SERVICE LETTER NO. SL-1

EFFECTIVITY: Rockwell Commander 112 S/N 3 through 79

SUBJECT: Rudder Assembly

Figure 1.

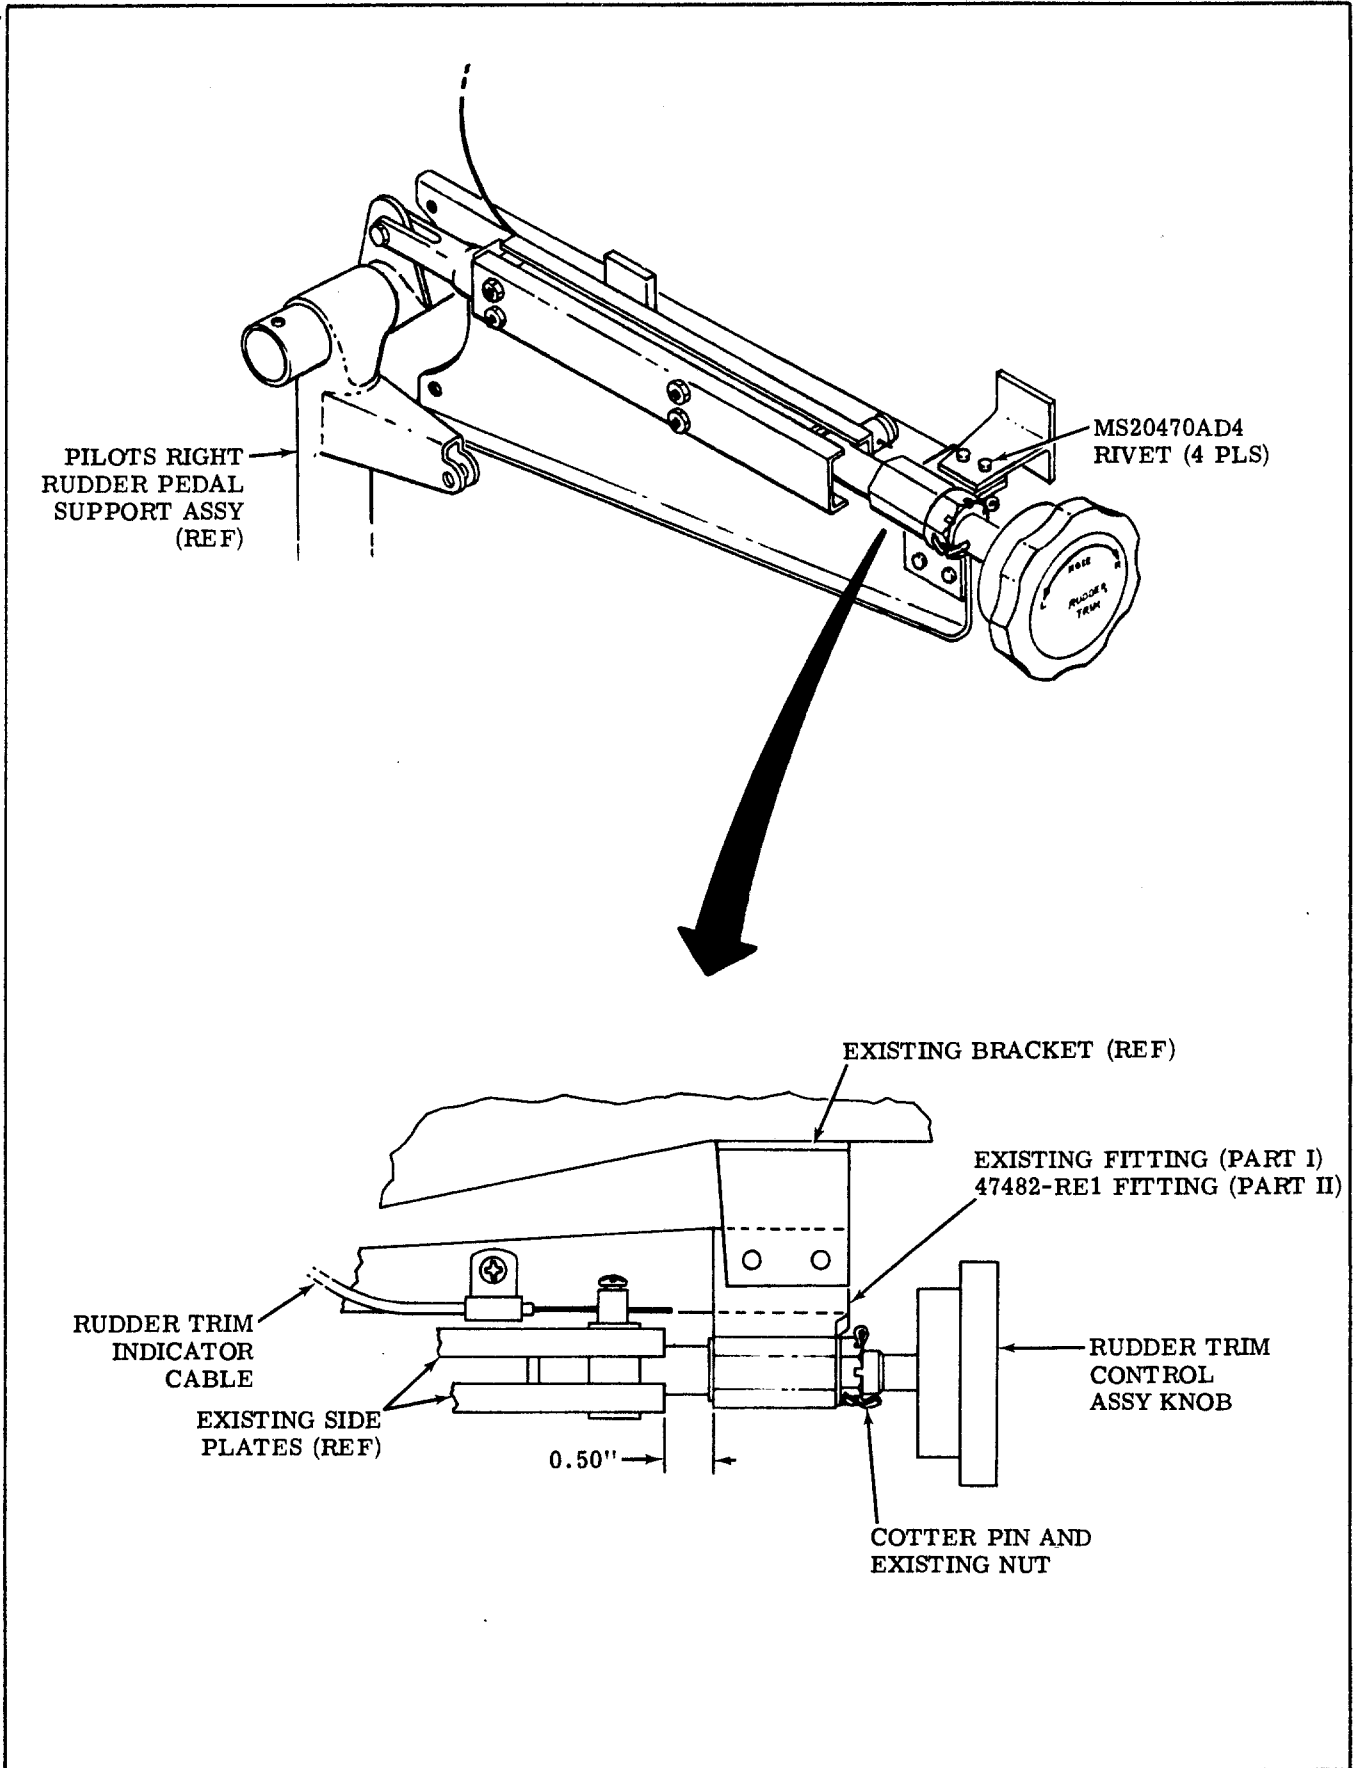
1. Remove cotter pin from existing nut on rudder trim control assembly shaft and back nut off threads (see Figure 1.).
2. Turn rudder trim control assembly knob counterclockwise until stop is contacted and then turn control knob clockwise exactly six (6) complete turns and clamp a stiff straight edge to pilot's rudder pedals.

3. Check for 0.50 (\pm 0.03) inch dimension between rudder trim control assembly fitting and side plate (see Figure 1.).
4. If dimension between rudder trim control assembly fitting and side plate exceeds 0.53-inch, remove straight edge from pilot's rudder pedals and proceed to Part II.
5. If dimension between rudder trim control assembly fitting and side plate is 0.50 (\pm 0.03) inch, remove straight edge from pilot's rudder pedals.
6. Remove rudder trim control assembly knob and nut, loosened in step 1., from shaft.
7. Disconnect forward shaft of rudder trim control assembly from top of pilot's right rudder pedal support assembly.
8. Disconnect rudder trim indicator cable from rudder trim control assembly and remove rudder trim control assembly from airplane.
9. Disassemble rudder trim control assembly and discard existing springs.

10. Turn rudder trim control assembly knob counterclockwise until stop is contacted and then turn control knob clockwise exactly six (6) complete turns and clamp a stiff straight edge to pilot's rudder pedals.
11. Position 47482-RE1 fitting on rudder trim control assembly shaft to 0.50 (\pm 0.03) inch dimension shown in Figure 1. and clamp fitting to rudder trim control assembly bracket.

12. Drill and install 47482-RE1 fitting on rudder trim control assembly bracket with MS20470AD4 rivets (4 places) (see Figure 1.).
13. Reinstall existing nut and cotter pin on rudder trim control assembly shaft.
14. Reconnect rudder trim indicator cable to rudder trim control assembly.
15. Check rudder trim indicator rigging as outlined in the Airplane Maintenance Manual, Section VII.
16. Proceed to RECORD COMPLIANCE.

Figure 2.

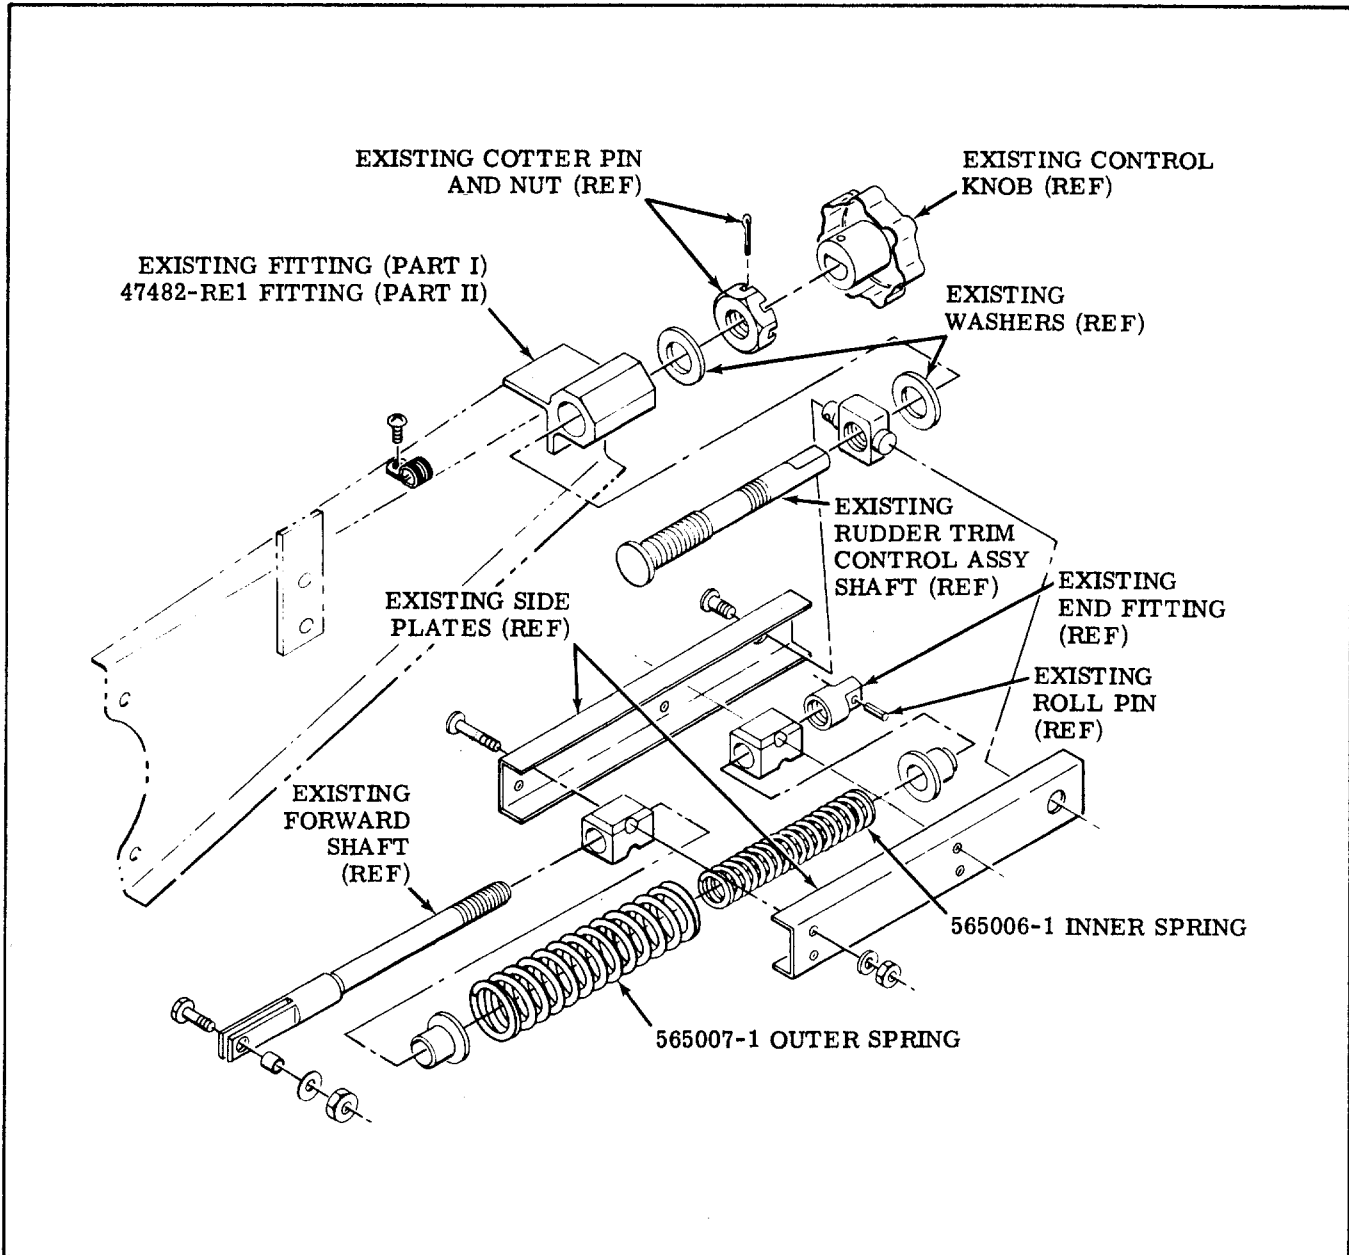
10. Install new 565006-1 inner spring and 565007-1 outer spring and reassemble rudder trim control assembly (see Figure 2.).
11. Reinstall rudder trim control assembly in airplane using existing hardware.
12. Reinstall existing washers, nut and cotter pin, removed in step 1., and rudder trim control assembly knob (see Figure 2.).
13. Reconnect rudder trim indicator cable to rudder trim control assembly.
14. Check rudder trim indicator rigging as outlined in the Airplane Maintenance Manual, Section VII.
15. Proceed to RECORD COMPLIANCE.

5. Install new 565006-1 inner spring and 565007-1 outer spring and reassemble rudder trim control assembly (see Figure 2.).
6. Remove and discard existing fitting from rudder trim control assembly bracket (see Figure 2.).

Figure 1.

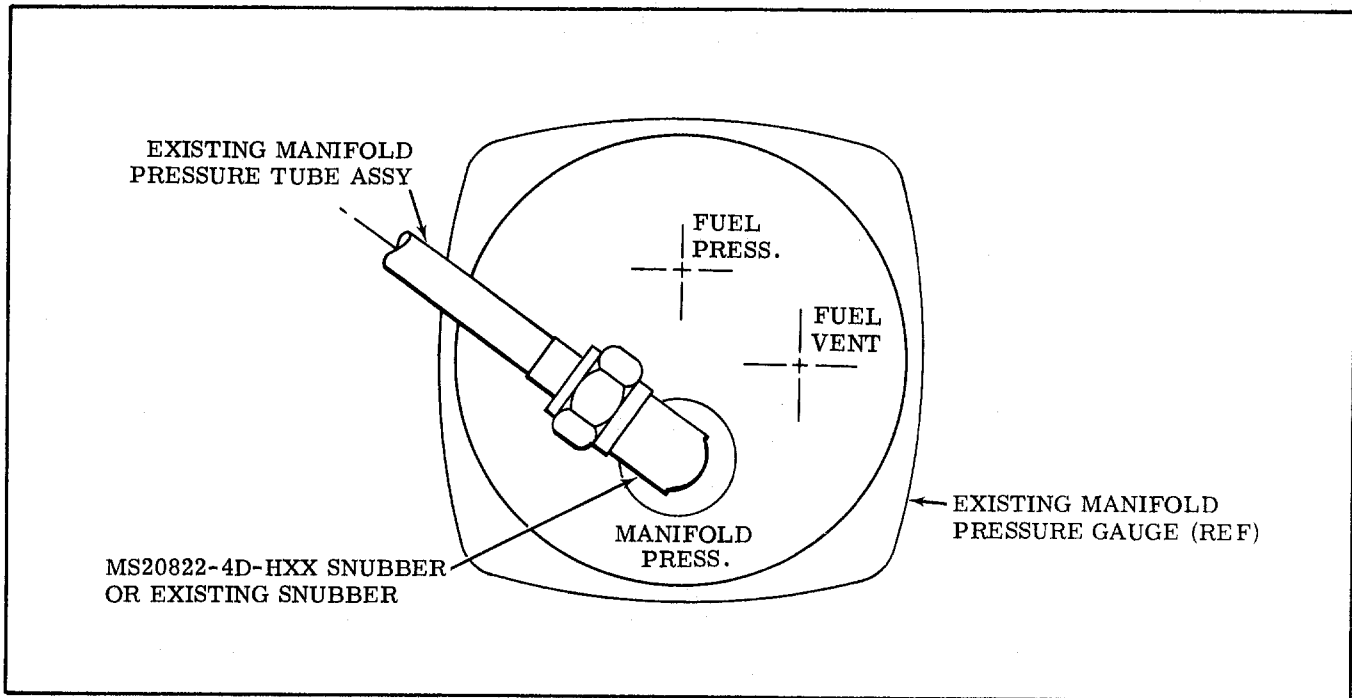
1. Disconnect manifold pressure tube assembly from existing fitting in manifold pressure gauge port (see Figure 1.).
2. Remove and disconnect existing manifold pressure gauge fitting.
3. Remove and discard Phillips head dampening screw located inside manifold pressure port of manifold pressure gauge.

5. Install MS20822-4D-HXX pressure snubber in manifold pressure gauge (see Figure 1.).
6. Connect existing manifold pressure tube assembly to pressure snubber (see Figure 1.).
7. Fill out and mail Compliance Card and proceed to RECORD COMPLIANCE.

1. Disconnect manifold pressure tube assembly from existing pressure snubber in manifold pressure gauge port (see Figure 1.).
2. Remove existing pressure snubber from manifold pressure gauge.
3. Remove and discard Phillips head dampening screw (if installed) located inside manifold pressure port of manifold pressure gauge.

5. Install existing pressure snubber in manifold pressure gauge (see Figure 1.).
6. Reconnect existing manifold pressure tube assembly to existing pressure snubber (see Figure 1.).
7. Fill out and mail Compliance Card.

Figure 1.

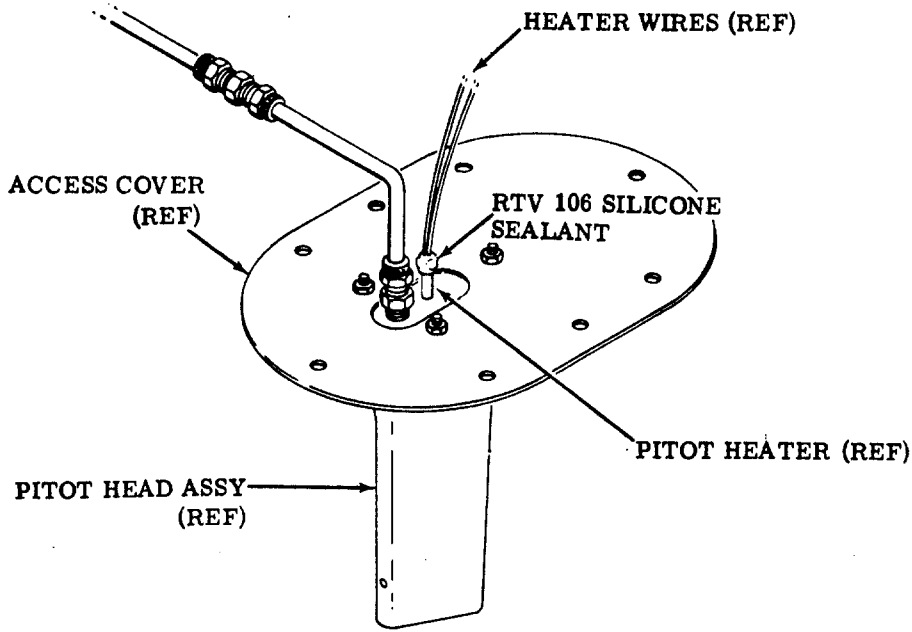
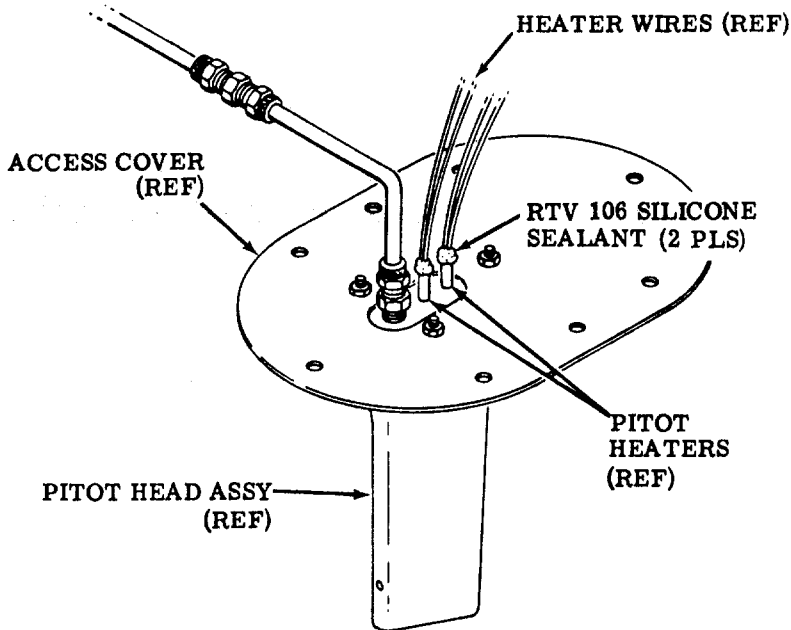
1. Remove screws attaching pitot head assembly access cover to wing and pull down on pitot head assembly.
2. Check dimension from top of pitot heater(s) to top of pitot head assembly to assure that pitot heater(s) is installed properly in pitot head assembly. Dimension should be 0.375-inch to 0.50-inch (see Figure 1.)

- a. Remove pitot heater(s) from pitot head assembly.
 - b. Ream 0.1875-inch diameter hole(s) to depth specified in Figure 1.
 - c. Inspect pitot heater wires for possible fraying of insulation or bare wires.

Figure 1.

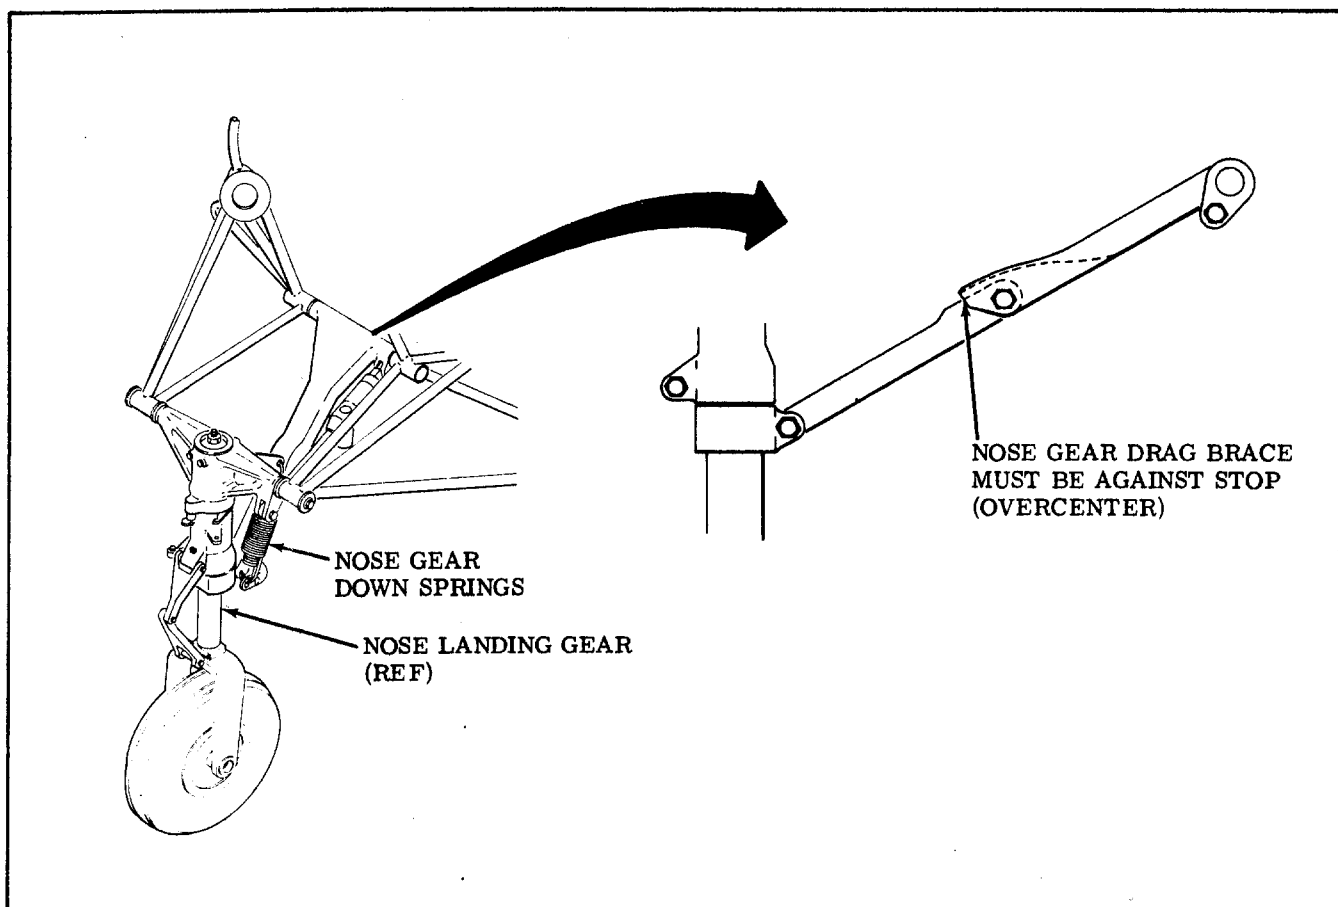
4. If either spring tension load is not within load limits listed in step 3., remove and replace both springs as necessary.
5. If spring tension loads are within load limits listed in step 3., reconnect lower ends of nose gear down springs to nose landing gear.
6. With the nose landing gear extended, assure that nose gear drag brace is overcenter (see Figure 1.) as follows:

- a. With the cylinder lock engaged on the nose gear actuating cylinder and the drag brace in a relaxed position, the drag brace must be resting on the overcenter stop at the knuckle area.
- b. Push up on the drag brace pivot point and check for a clearance of 0.040 to 0.125-inch.

Figure 1.

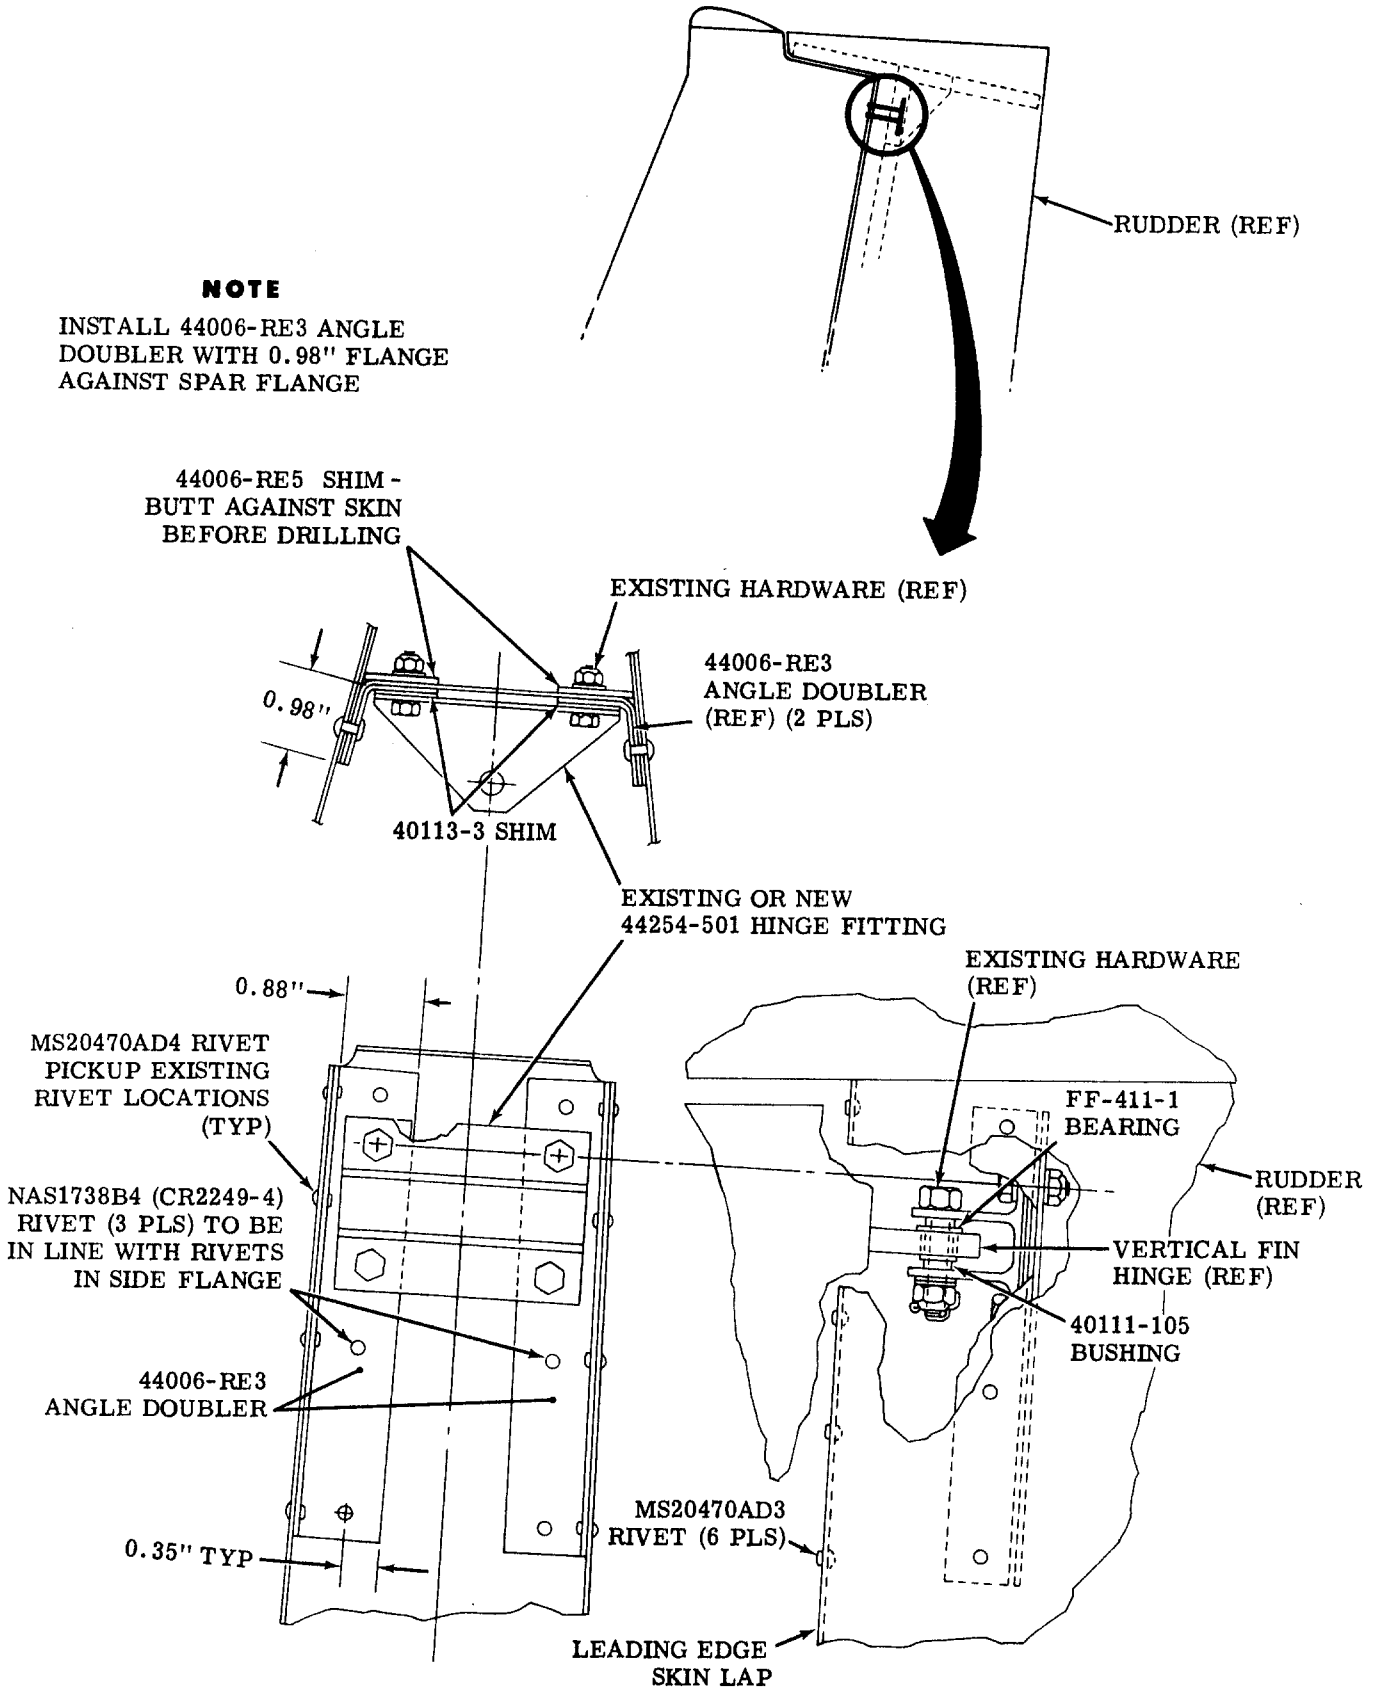
- b. Remove upper six (6) rivets from rudder assembly leading edge skin lap.
 - c. Stop drill all cracks with a No. 40 (0.098) diameter drill.
 - d. Locate, drill and install 44006-RE3 angle doubler (2 places) on rudder assembly (see Figure 1.).

- e. If existing hinge fitting is to be used, trim 0.06-inch to 0.07-inch from each end of existing hinge fitting.
 - f. Install existing or new 44254-501 hinge fitting, 44006-RE5 shim (2 places) and 40113-3 shim (2 places) using existing hardware (see Figure 1.).

10. Reinstall tip on rudder assembly.
 11. Remove and discard existing oilite bearing from upper vertical fin hinge.
 12. Install FF-411-1 bearing in upper vertical fin hinge and ream hole in new bearing to 0.317/0.318-inch (see Figure 1.).
